# SUPPLEMENTAL PUBLIC NOTICE

Public Notice Number: 2005-00011-J1 (supp)  
Issue Date: July 26, 2005  
Expiration Date: August 24, 2005

**REVISED WORK DESCRIPTION**

PROPOSED DREDGING  
WRECK POND  
BOROUGHES OF SPRING LAKE AND SEA GIRL  
COUNTY OF MONMOUTH

**DREDGING PLAN**

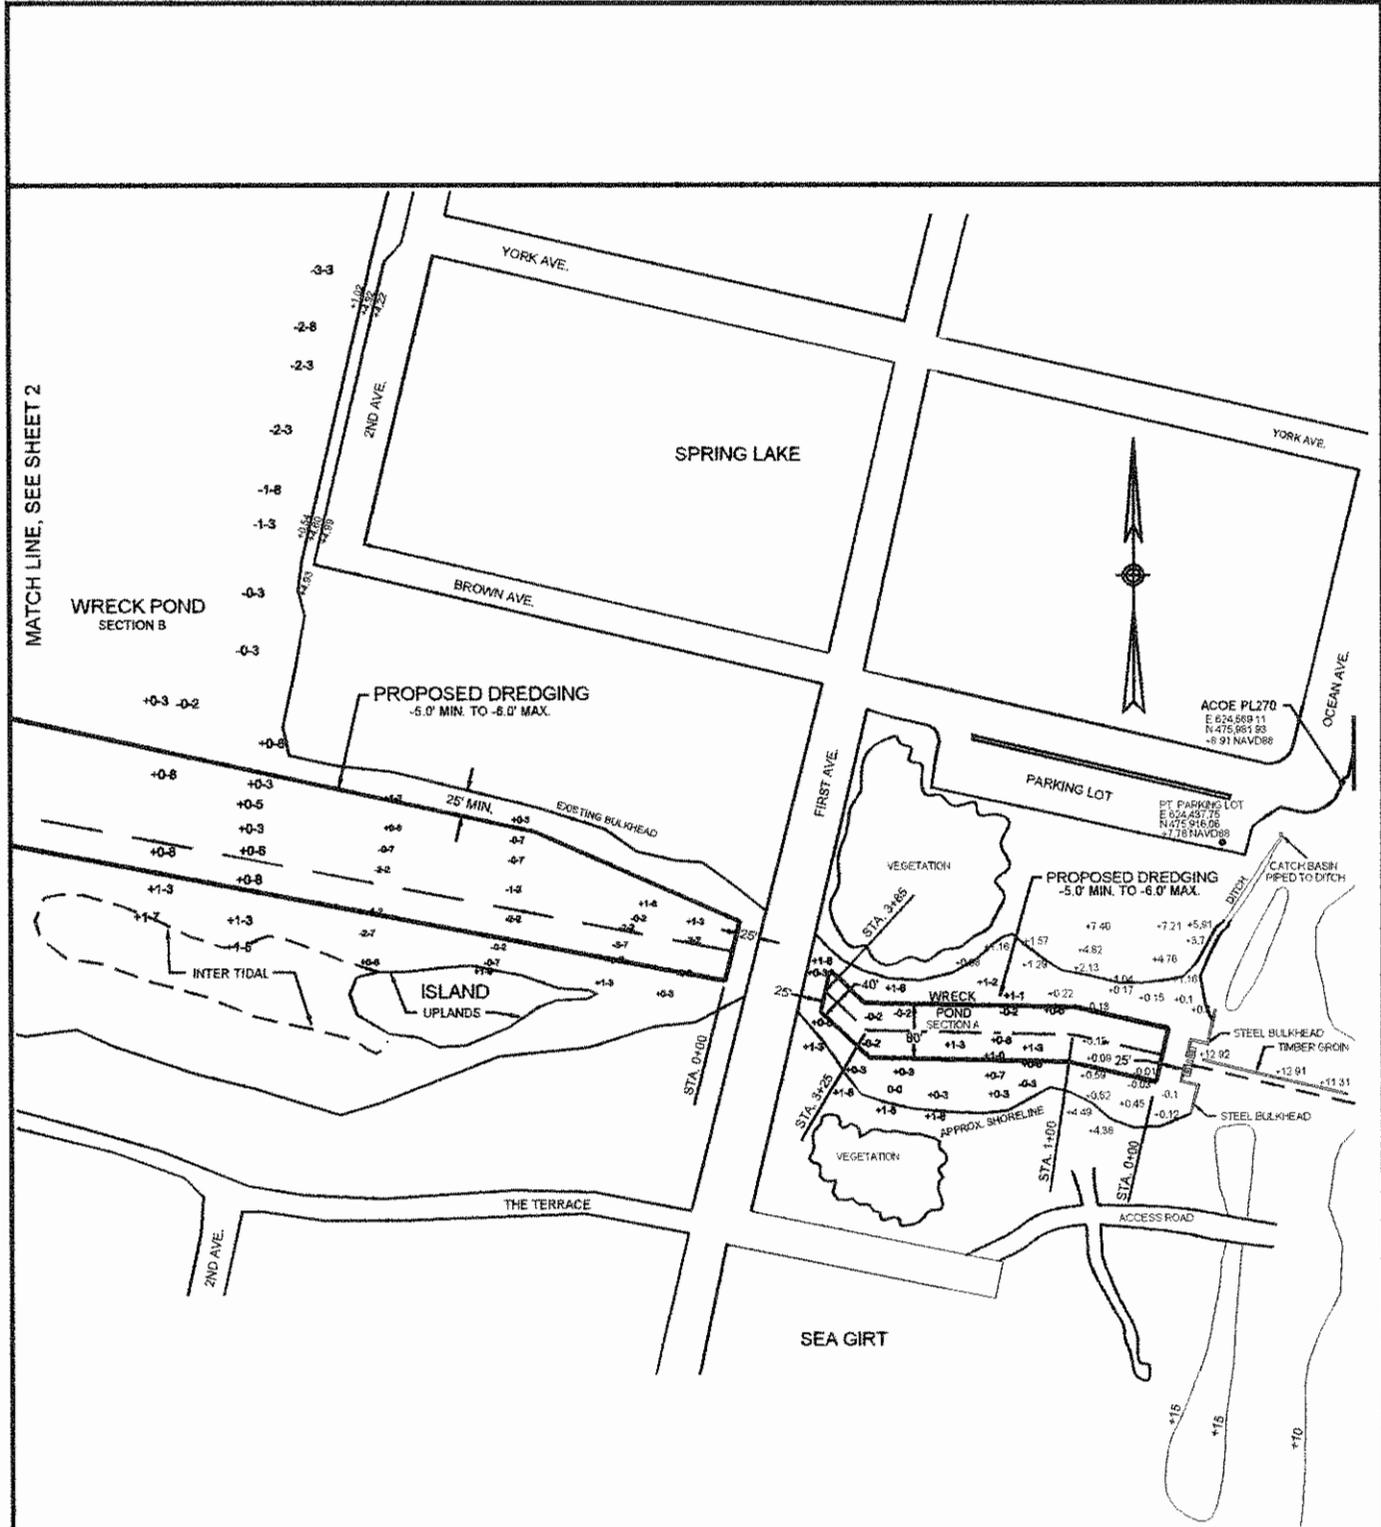
1. Redesigning the dredging area in Section A. The revised dredge area in Section A has a maximum width of 80 feet and has left much of the sandy shallows adjacent to the shoreline intact. This area is prime foraging habitat for adult plovers.
2. Creation of a crossover to the back pond to allow plovers access to additional foraging habitat, Section A area was revised to obtain a slope of 1-foot vertical to 10-foot horizontal and 100-foot in width to further enhance plover and amaranth habitat.
3. Redesigning the Section B dredging area and elimination of dredging of the island from the proposed project.

The proposed work would involve the one-time hydraulic dredging of two sections, A and B at the ocean end of Wreck Pond as depicted on the sheet 3 of 8 attached to this public notice. The dredging would be to a depth of six (6) feet below the plane of Mean Low Water. As shown on the attached drawings, Section A is located east of First Avenue and Section B is located within the main pond directly west of First Avenue. The total volume of material to be dredged is approximately 80,000 cubic yards. Only dredged material containing at least 75 percent sand would be placed upon the ocean beaches as depicted on the attached drawings. This beach fill would follow the beach profile engineered by U.S. Army Corps of Engineers in the project entitled, "Atlantic Coast of New Jersey, Sandy Hook to Barnegat inlet, Beach Erosion control Project Section 1- Sea Bright to Ocean Township, New Jersey."
